ADDENDUM NO. 03

College of the Sequoias Tulare Campus CTE 4999 Bardsley Avenue Visalia, CA 93274

TETER Project No.: 21-12032.00

Date: 12/15/2022

20-12032 DRAWING C50⁻

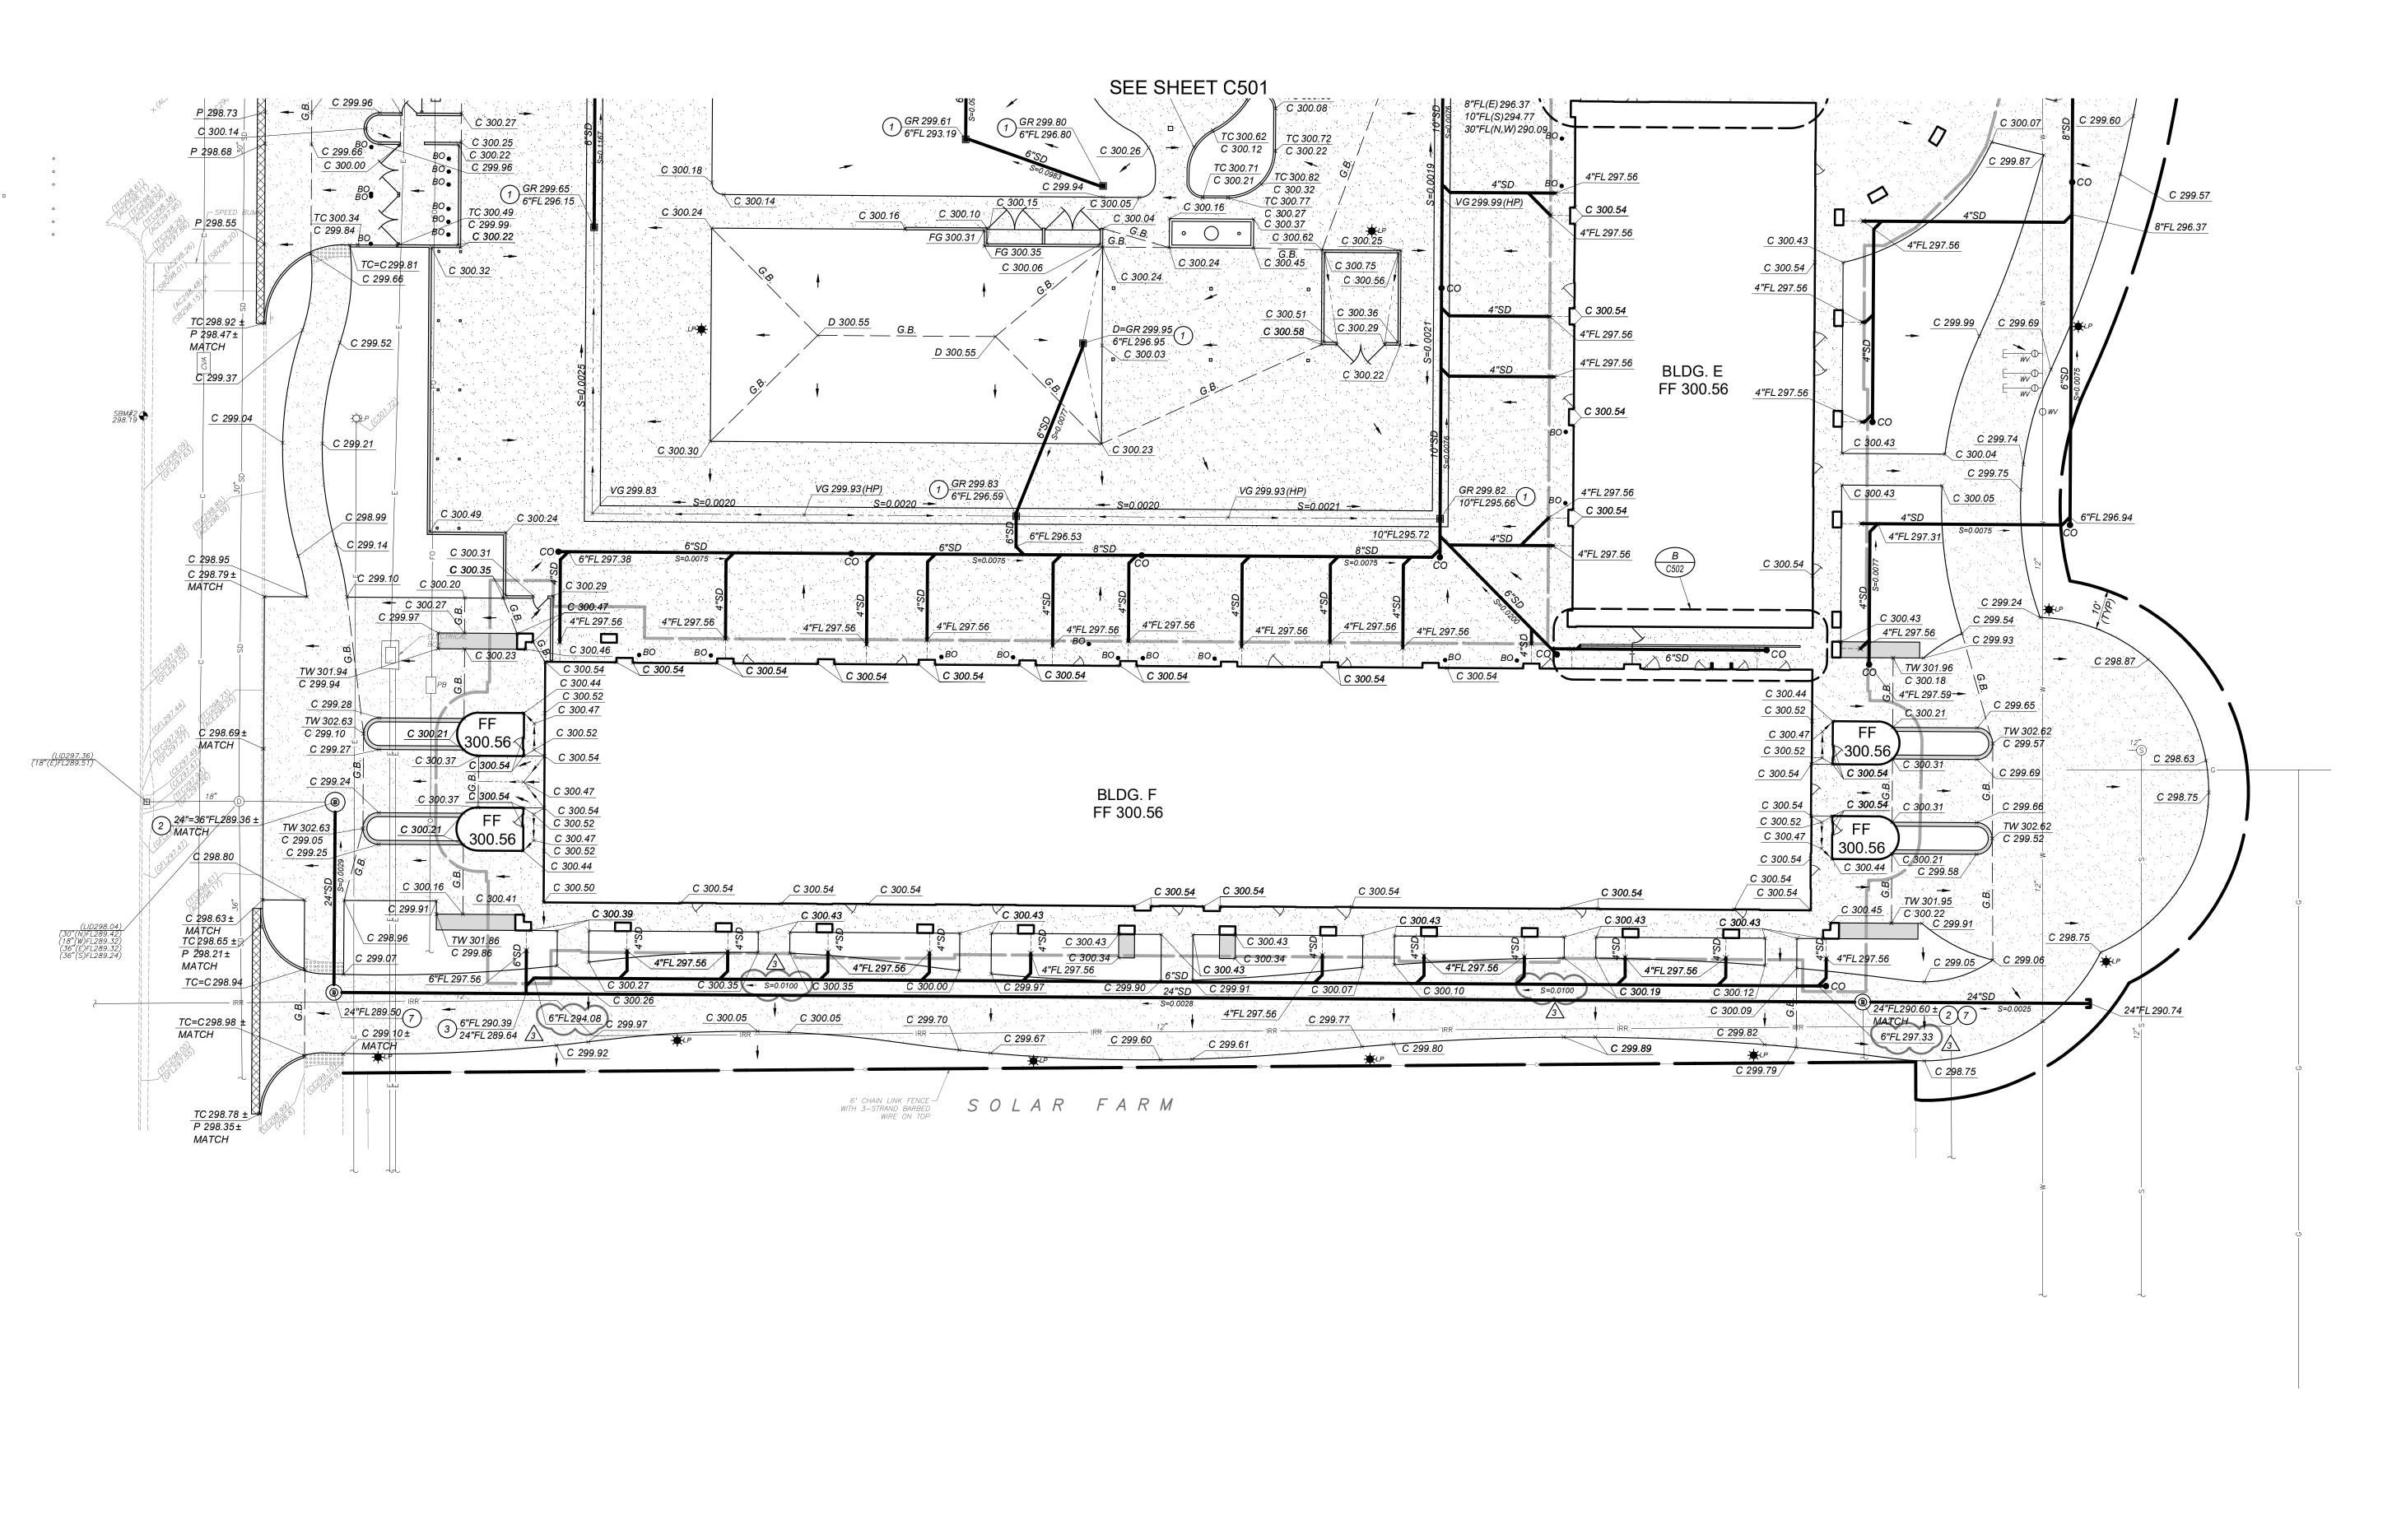
- A. Remove existing water valve on 4" fire sprinkler line in lieu of 6" fire hydrant line.
- DRAWINGS, SHEET C501 PARTIAL GRADING AND DRAINAGE PLAN, revise as follows:
 - A. Adjusted 4" storm drain lateral at northeast corner of Bldg. D.
- DRAWINGS, SHEET C502 PARTIAL GRADING AND DRAINAGE PLAN, revise as follows:
 - A. Adjusted 6" storm drain invert elevations and pipe slopes south of Bldg. F.
- **DRAWINGS, SHEET C601 PARTIAL UTILITY PLAN, revise as follows:**
 - A. Add PIV to 4" fire sprinkler line in lieu of 6" fire hydrant line.
 - B. Added dimensions to 8" fire water main in between Bldg. C and D
 - C. Adjusted 8" fire main at the pump house.
 - D. Adjusted 4" storm drain lateral at northeast corner of Bldg. D.
